URBAN DESIGN COMMISSION APPLICATION CITY OF MADISON

1. **Project Address:** 510 University Avenue

Project Title (if any): Hub at Madison II

The Hub at Madison II -UDC RE-SUBMITTAL

NORTH EAST ELEVATION

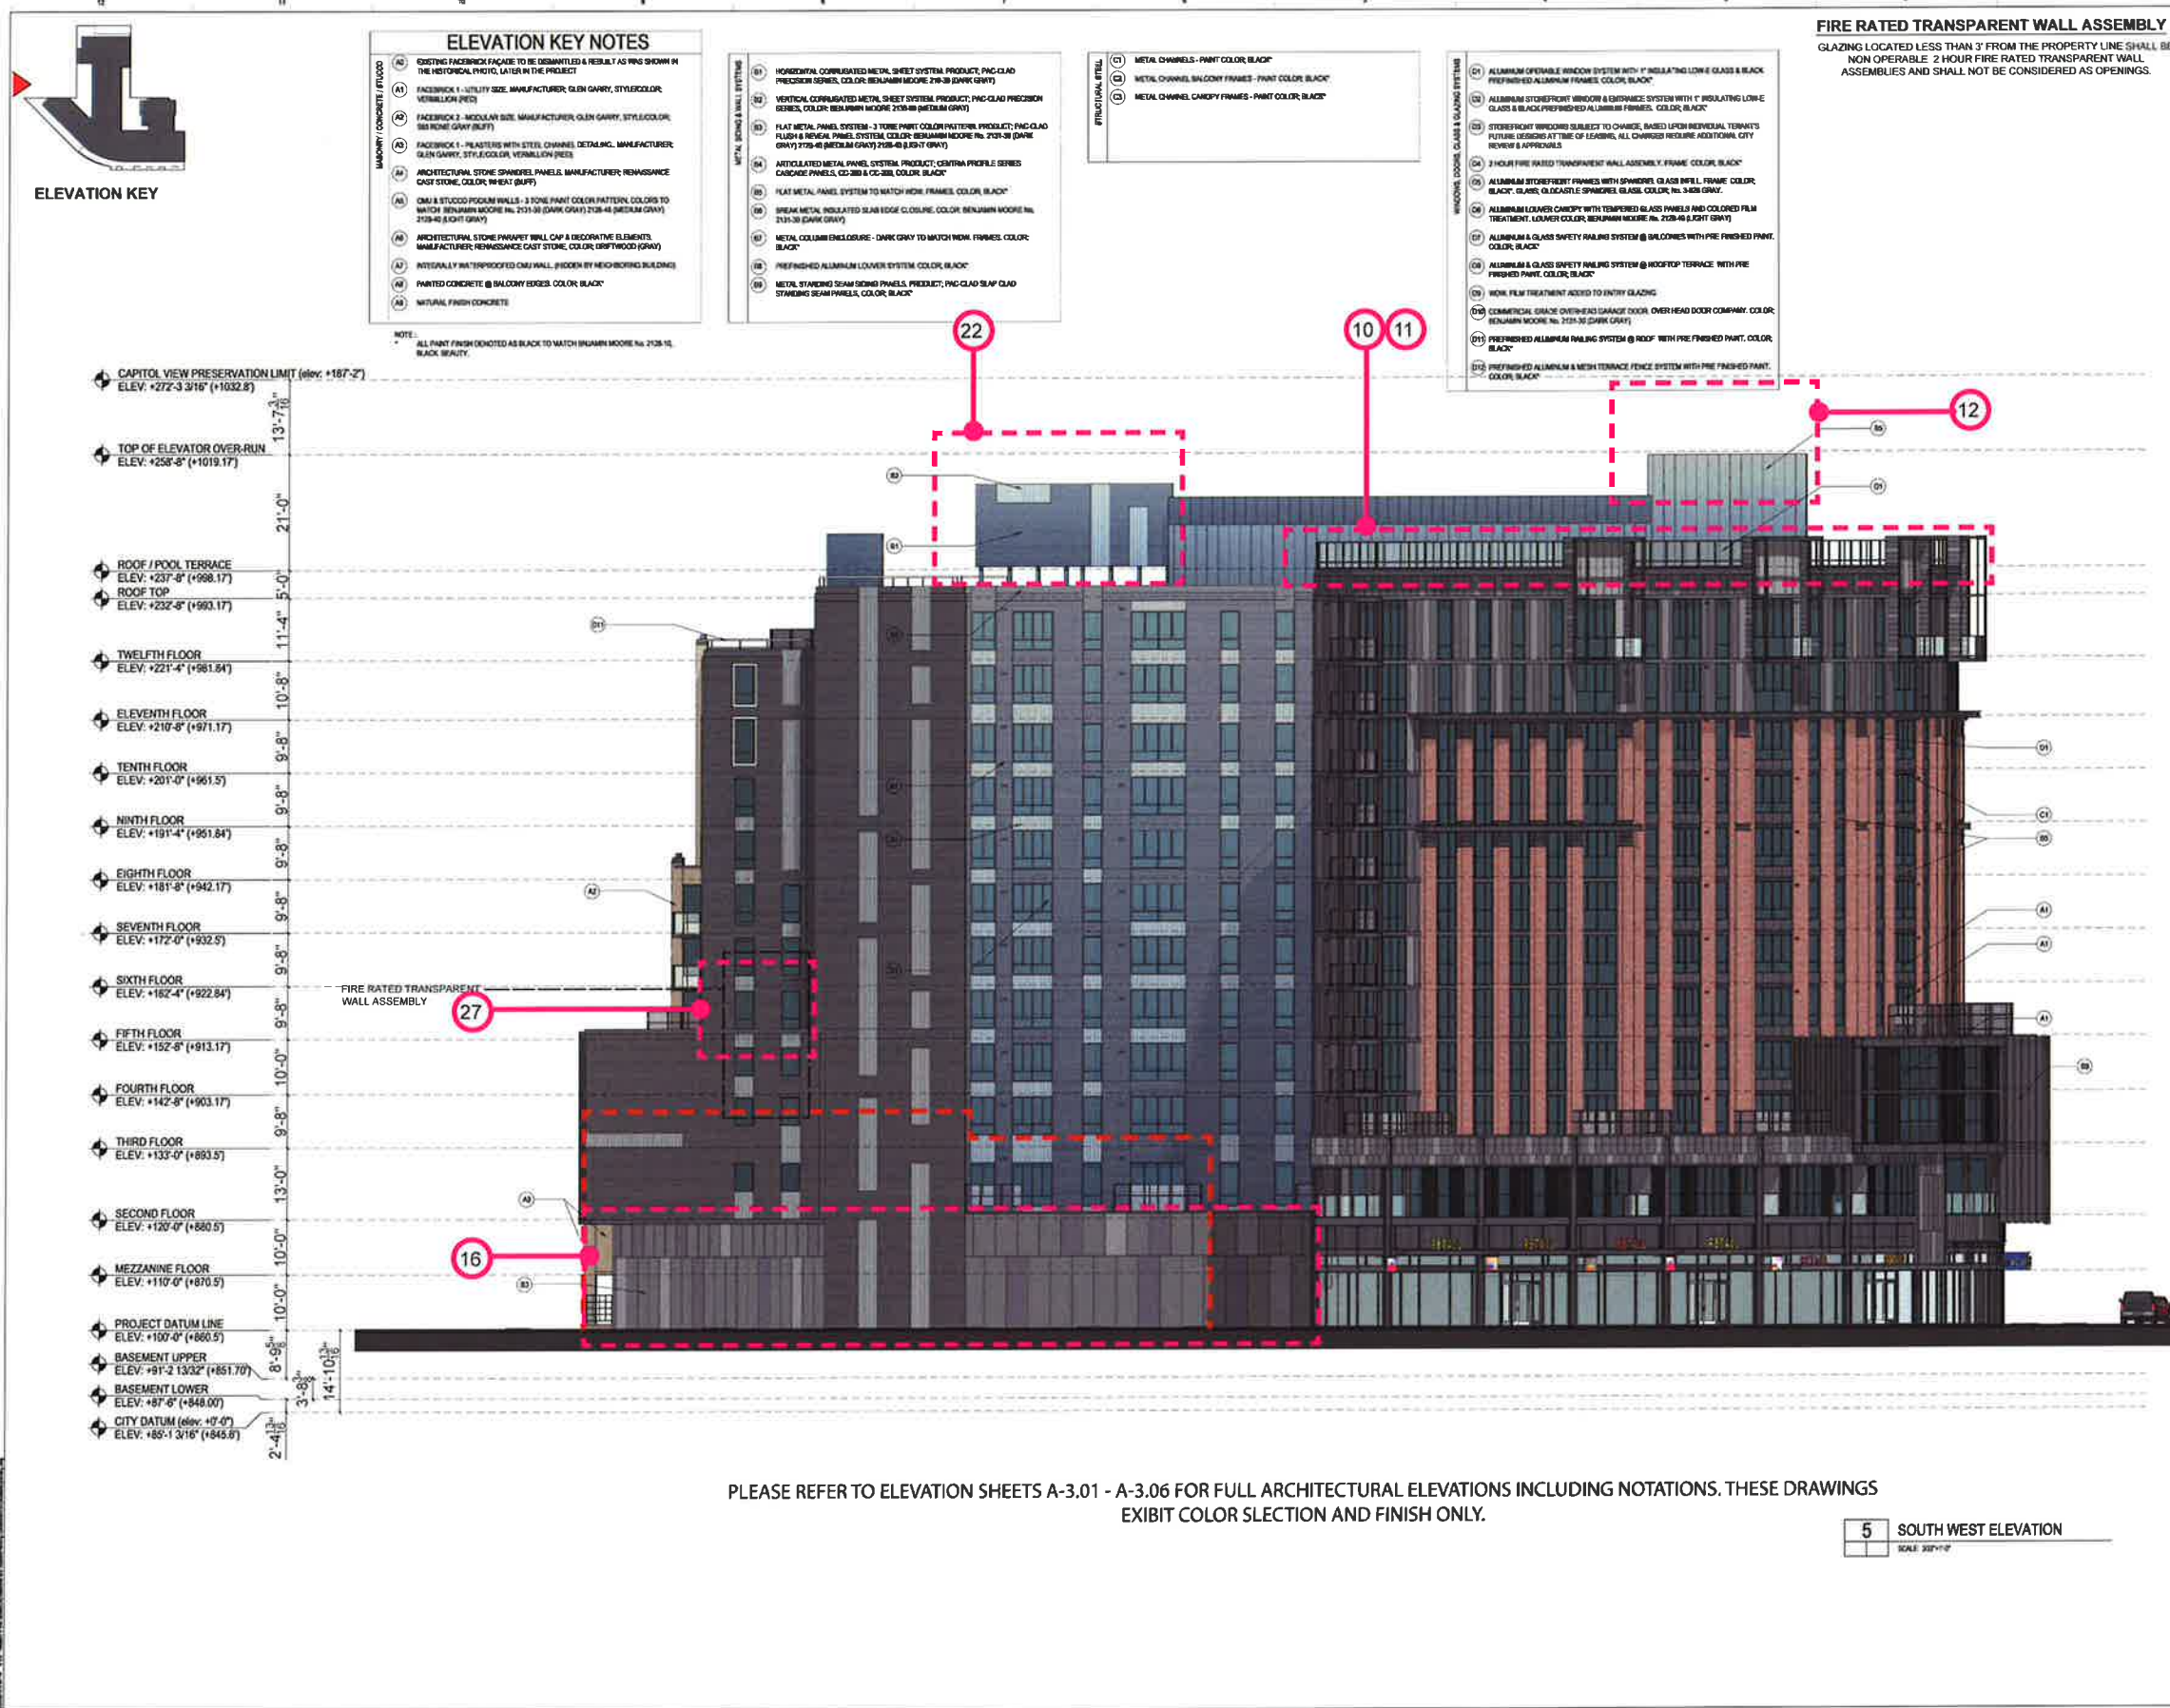
1. Brick knee wall added at University Ave. / Gorham St. storefront.
2. Residential and leasing lobby entry and canopies reduced from three to one. Film at lobby entry doors remove. Lobbies rationalizes into one connected space eliminating need for 3 entries. Canopy over entry redesigned to match cladding concept.

3. Storefront subdivisions simplified. Staggered pattern to match metal panel pattern.
4. Corner of University and alleyway revised to reflect change at fire rated vision triangle sightlines.

11. Glass Pool terrace screen scope reduced. Pool terrace size reduced.
12. Multiple lighting masts centralized in single mast to rear of lift overrun.
13. Second elevator overrun added.

14. Exhaust grills enlarged above garage door and entry glazing reduced accordingly. Mechanical requirement
15. Black brick cladding at street. Replace CMU and stucco cladding at street.

16. CMU & stucco podium walls changes to scored CMU and patterned paint finish. Changed for constructability and maintenance issues. 16A change: CMU & stucco wall changed to concrete shear wall with reveal lines and patterned paint finish.

17. Garage door colors simplified to 1 color plus glass.
18. Scuppers added at terraces. Flood prevention.
19. Vision glass added. Spandrel panel glass replaced.

20. Planting removed from roof on 8th floor. Maintenance access not possible through slider windows.
21. Window location altered.
22. Mechanical screen height increased from 20' to 23'-6"

23. Mechanical exhaust/intake grills. Mechanical vent requirements.
24. Brick clad columns changed to natural finish columns.
25. Fire rated windows added. At share light well to neighbor.

26. Brick knee wall remove from metal panel areas.
27. Windows removed. Plan changes, windows no longer possible.
28. Door type change. Size reduced to suit exterior space plan.

5 SOUTH WEST ELEVATION
SCALE: 3/32"=1'-0"

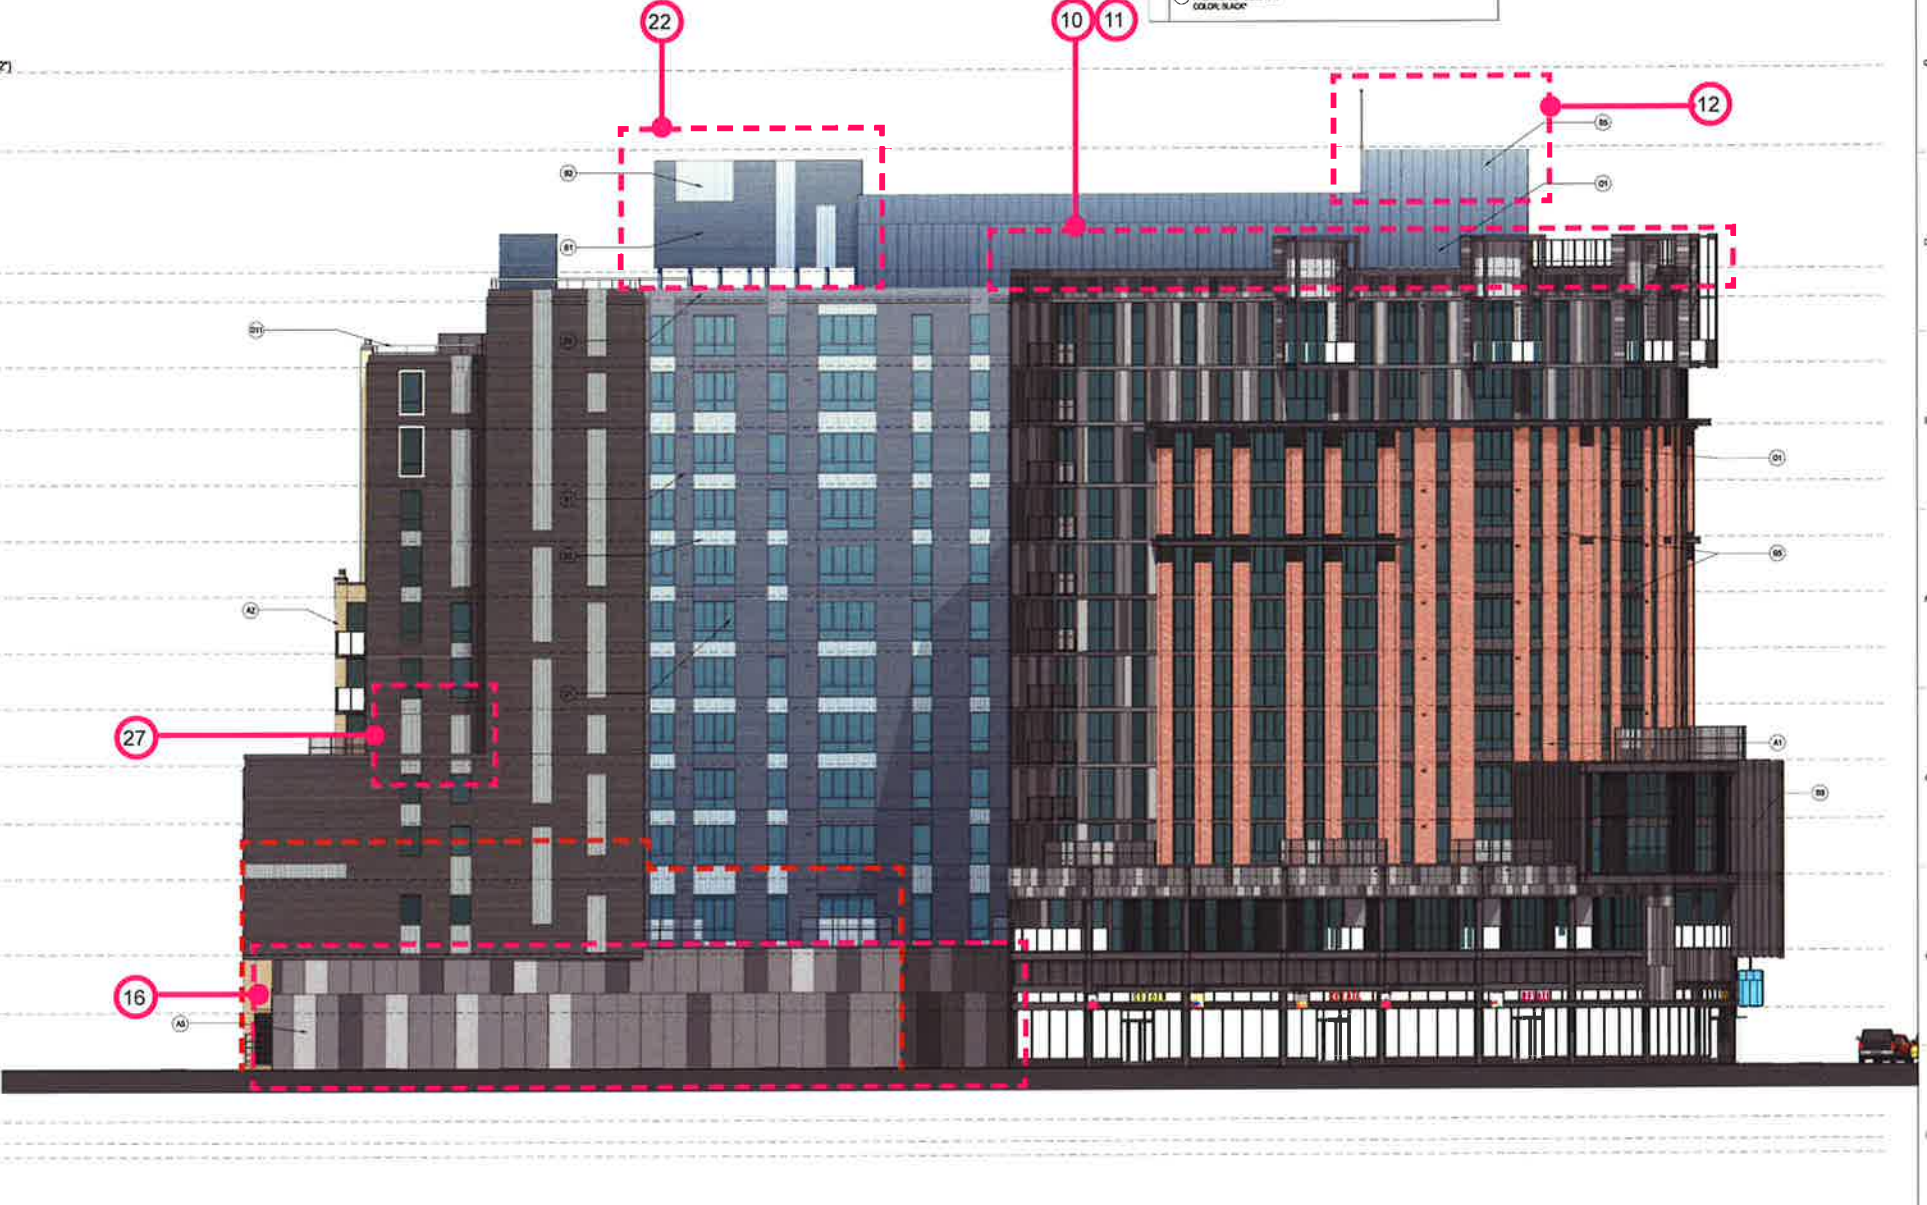
- Brick knee wall added at University Ave. / Gorham St. storefront.
- Residential and leasing lobby entry and canopies reduced from three to one. Film at lobby entry doors remove. Lobbies rationalizes into one connected space eliminating need for 3 entries. Canopy over entry redesigned to match cladding concept.

- Storefront subdivisions simplified. Staggered pattern to match metal panel pattern.
- Corner of University and alleyway revised to reflect change at fire rated vision triangle sightlines.

- Glass Pool terrace screen scope reduced. Pool terrace size reduced.
- Multiple lighting masts centralized in single mast to rear of lift overrun.
- Second elevator overrun added.

- Exhaust grills enlarged above garage door and entry glazing reduced accordingly. Mechanical requirement
- Black brick cladding at street. Replace CMU and stucco cladding at street.

- CMU & stucco podium walls changes to scored CMU and patterned paint finish. Changed for constructability and maintenance issues. 16A change: CMU & stucco wall changed to concrete shear wall with reveal lines and patterned paint finish.

- Garage door colors simplified to 1 color plus glass.
- Scuppers added at terraces. Flood prevention.
- Vision glass added. Spandrel panel glass replaced.

- Planting removed from roof on 8th floor. Maintenance access not possible through slider windows.
- Window location altered.
- Mechanical screen height increased from 20' to 23'-6"

- Mechanical exhaust/intake grills. Mechanical vent requirements.
- Brick clad columns changed to natural finish columns.
- Fire rated windows added. At share light well to neighbor.

- Brick knee wall remove from metal panel areas.
- Windows removed. Plan changes, windows no longer possible.
- Door type change. Size reduced to suit exterior space plan.

6 NORTH ELEVATION
SCALE: 3/8"=1'-0"

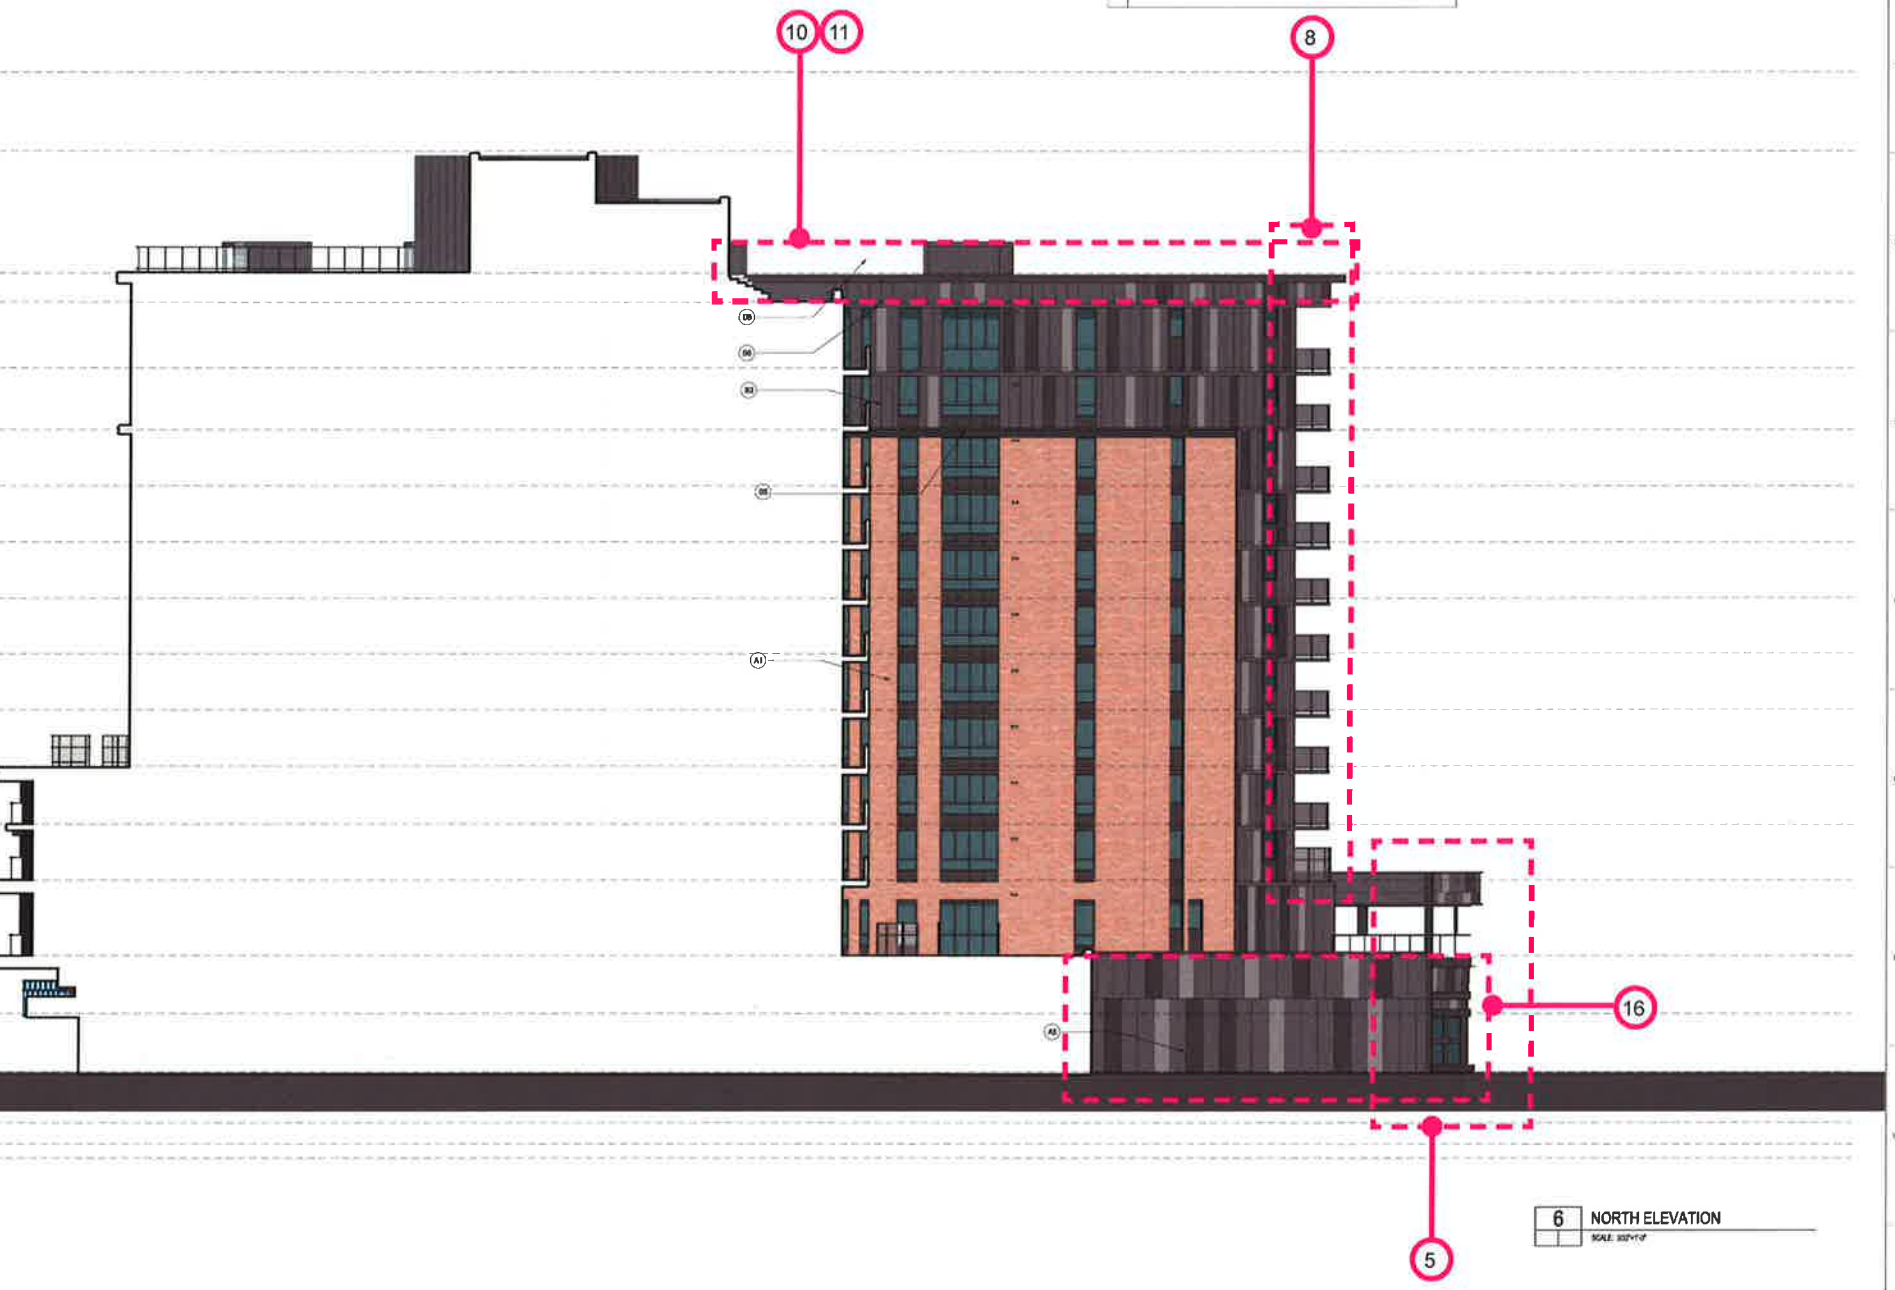
1. Brick knee wall added at University Ave. / Gorham St. storefront.
2. Residential and leasing lobby entry and canopies reduced from three to one. Film at lobby entry doors remove. Lobbies rationalizes into one connected space eliminating need for 3 entries. Canopy over entry redesigned to match cladding concept.

3. Storefront subdivisions simplified. Staggered pattern to match metal panel pattern.
4. Corner of University and alleyway revised to reflect change at fire rated vision triangle sightlines.

11. Glass Pool terrace screen scope reduced. Pool terrace size reduced.
12. Multiple lighting masts centralized in single mast to rear of lift overrun.
13. Second elevator overrun added.

14. Exhaust grills enlarged above garage door and entry glazing reduced accordingly. Mechanical requirement
15. Black brick cladding at street. Replace CMU and stucco cladding at street.

16. CMU & stucco podium walls changes to scored CMU and patterned paint finish. Changed for constructability and maintenance issues. 16A change: CMU & stucco wall changed to concrete shear wall with reveal lines and patterned paint finish.

17. Garage door colors simplified to 1 color plus glass.
18. Scuppers added at terraces. Flood prevention.
19. Vision glass added. Spandrel panel glass replaced.

20. Planting removed from roof on 8th floor. Maintenance access not possible through slider windows.
21. Window location altered.
22. Mechanical screen height increased from 20' to 23'-6"

23. Mechanical exhaust/intake grills. Mechanical vent requirements.
24. Brick clad columns changed to natural finish columns.
25. Fire rated windows added. At share light well to neighbor.

26. Brick knee wall remove from metal panel areas.
27. Windows removed. Plan changes, windows no longer possible.
28. Door type change. Size reduced to suit exterior space plan.
